CITY OF MERCED
Planning & Permitting Division

STAFF REPORT: #15-07

SUBJECT: **Design Review Application #15-01**, initiated by Galloway Planning, Architecture, Engineering, on behalf of KIF, LLC, property owner. This application involves a request to construct an approximately 10,140-square-foot tire store near the southeast corner of West 16th Street and Canal Street (420 W. 16th Street) within a Central Commercial (C-C) Zone. *PUBLIC HEARING*

DESIGN REVIEW #15-01
LES SCHWAB

A2.1

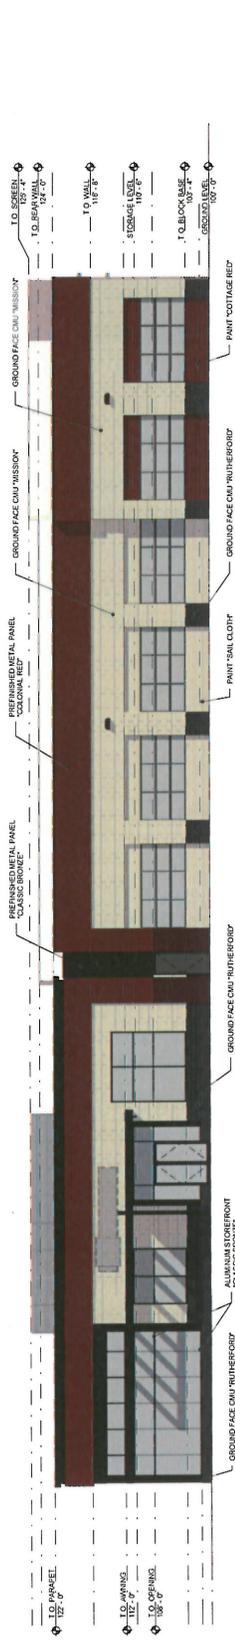
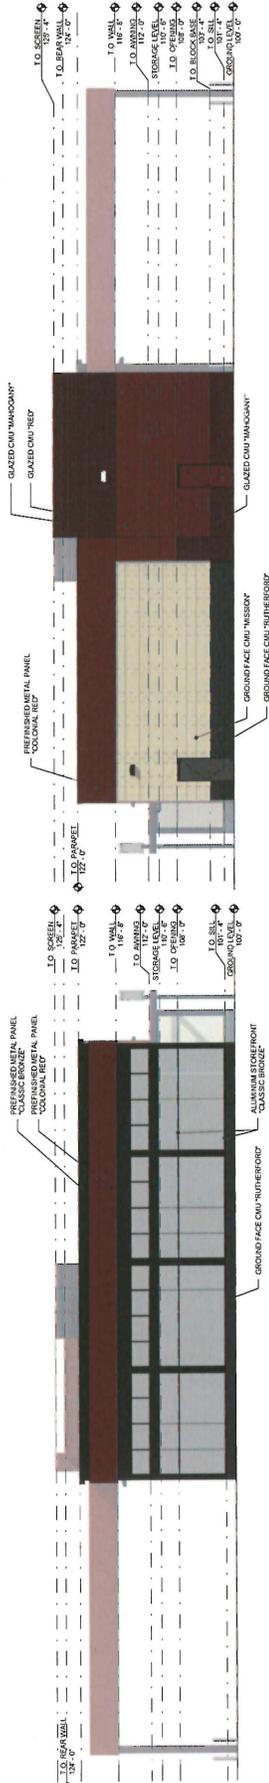
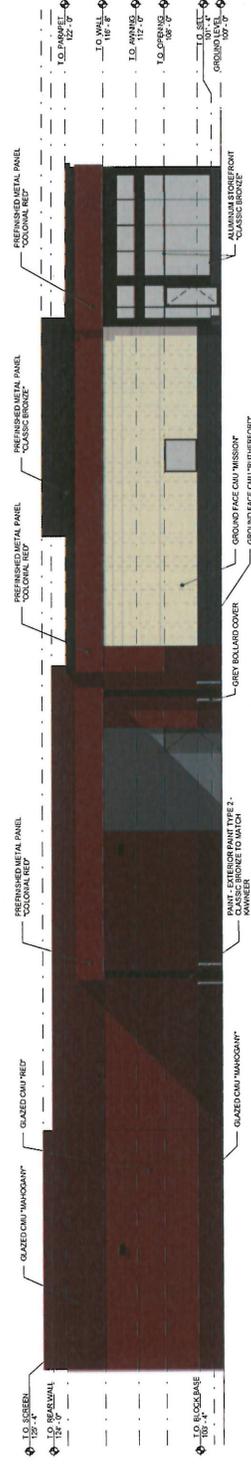
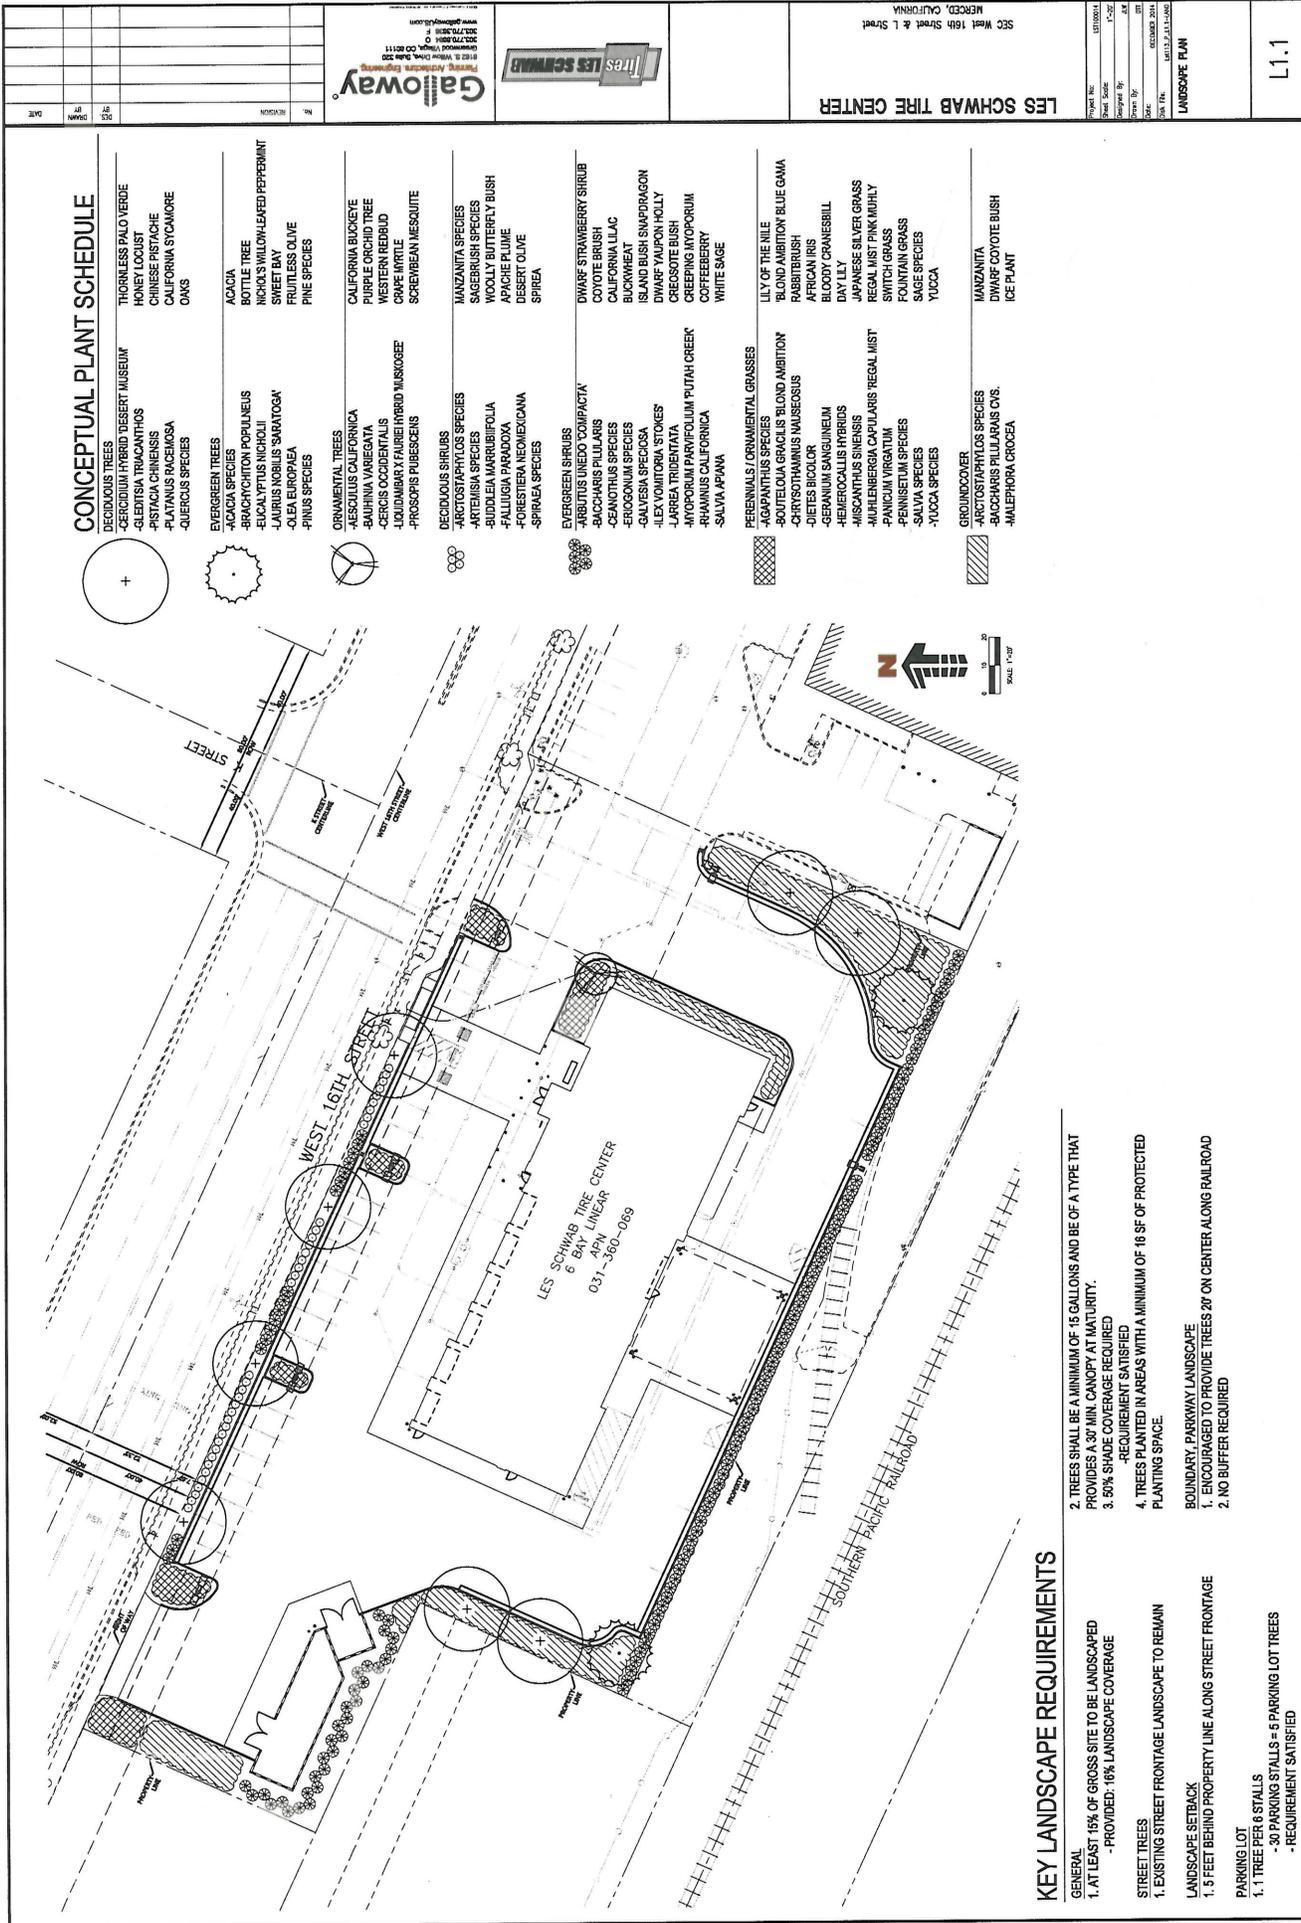
The building design incorporates horizontal lines with a variety of finishes to provide interest and detail (Attachment D). The roof is flat with an approximately 6-foot tall parapet. The building wall would have a ground face CMU finish and the parapet would be constructed of a prefinished metal panel. The color scheme includes earth tone shades of tan/off-white, gray, and deep red (colored elevations and a material board will be provided at the meeting). The northeast corner of the building incorporates glass storefront windows to add another design element to the building. Glass is also used to enclose the vestibule entrance which extends from the building wall to provide depth to the design. The service bay doors would include glass panels to break up the expanse of the roll-up doors. A park bench would be provided on the east side of the vestibule to provide an additional feature to the design. All roof-mounted equipment would be screened from view by the parapet as required by Condition #22.

SITE PLAN

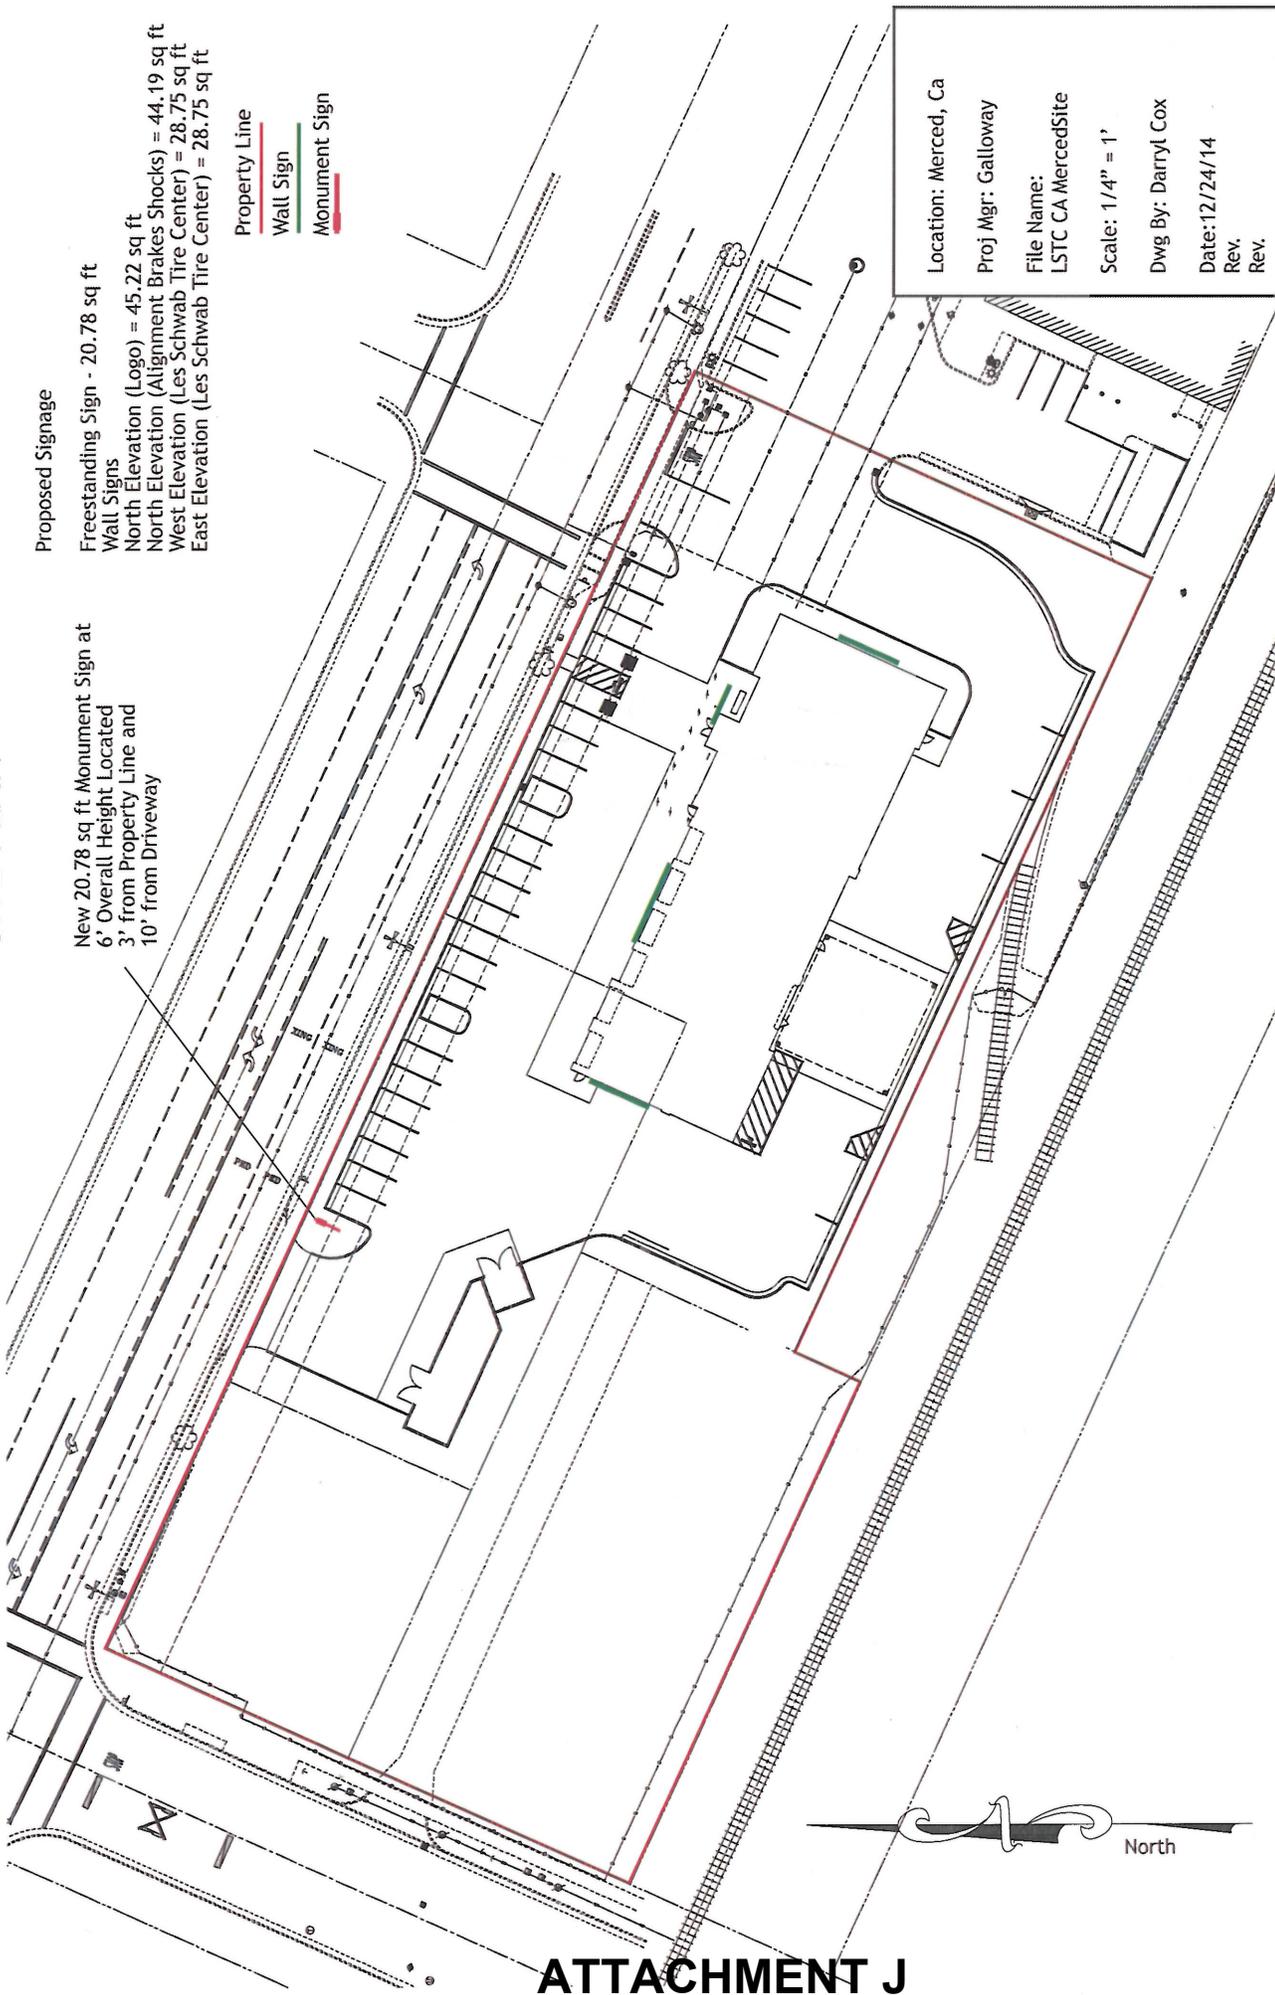
The Sign Regulations for Downtown allows for a monument sign not exceeding 6 feet in height or exceeding 30 square feet of sign area per face/side. The proposed monument sign is 6 feet tall and has a sign area of 25 square feet per face (Attachment I). Therefore, it complies with the Sign Regulations for Downtown. Because the proposed location of the monument sign is near a driveway (Attachment J) entrance, the applicant would need to demonstrate that the sign is located outside the 10-foot visual triangle at the driveway entrance (Condition #20). If the sign is located within the 10-foot visual triangle, the height of the sign would be limited to 2 ½ feet tall. The sign may be relocated to another location on the site if the proposed location does not comply with the requirements of the visual triangle.

signing for a total of 204 square feet of signing on the building. Any sign allowance not used on the elevation for which it was calculated may be used on another elevation. The signs for the north, east, and west elevations are approved as proposed for a total of 148 square feet of signing. The monument sign (50 square feet) is approved with the following conditions: a) the sign shall be located outside the 10-foot visual triangle at the driveway entrance; and, b) the address shall be added to the bottom of the monument structure. At the time of building permit review, the applicant shall demonstrate that the monument sign will be outside the visual triangle and will not block visibility of oncoming traffic or pedestrians.
